Lahontan Regional Water Quality Control Board

December 12, 2013

REVIEW OF CHROMIUM PLUME MAPS, THIRD QUARTER 2013 GROUNDWATER MONITORING REPORT AND AGREEMENT WITH NORTHERN INVESTIGATION CONCEPT, PACIFIC GAS AND ELECTRIC COMPANY, HINKLEY, SAN BERNARDINO COUNTY (CLEANUP AND ABATEMENT ORDER NO. R6V-2008-0002A4) WDID 6B369107001

REQUEST FOR AN ACTION PLAN AND MORE INFORMATION IN REPORTS REQUIRED BY CLEANUP AND ABATEMENT ORDER NO. R6V-2008-0002 AND INVESTIGATIVE ORDER R6V-2013-0041

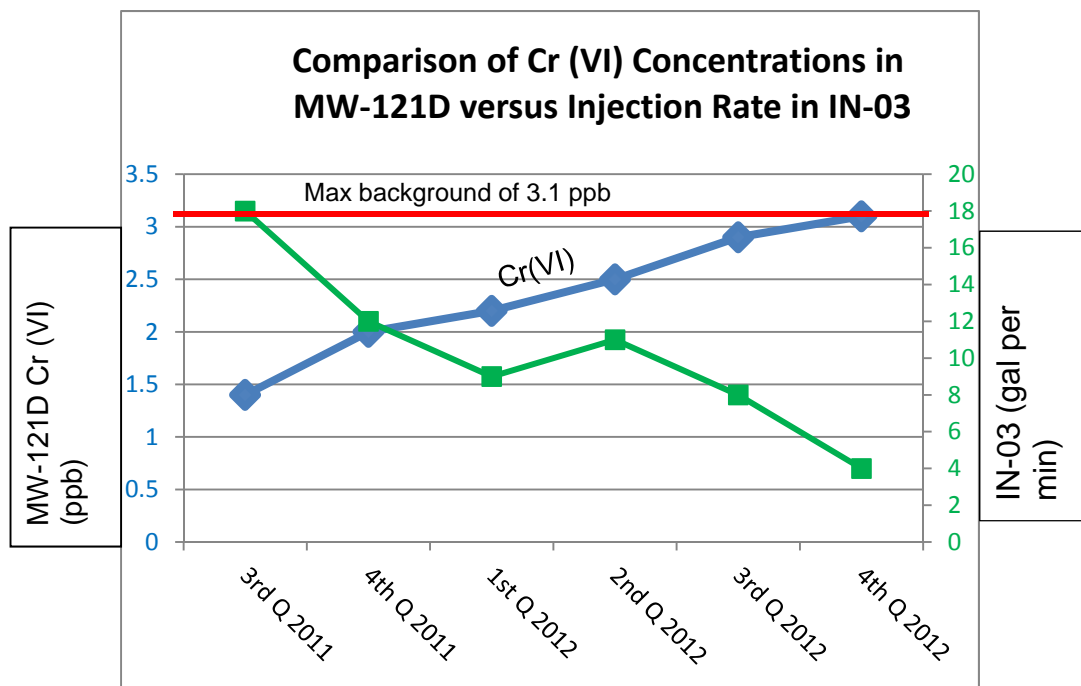
c. Amend Table 2-11 to show the total calculation of all columns for the quarter being reported.

The revised Table 2-11 contained in Attachment 1 to the report was not amended to include the total calculations during first quarter 2013 for four columns: total days in period pumping, % of period actively pumping, average injection rate when pumping, and average injection rate for period.
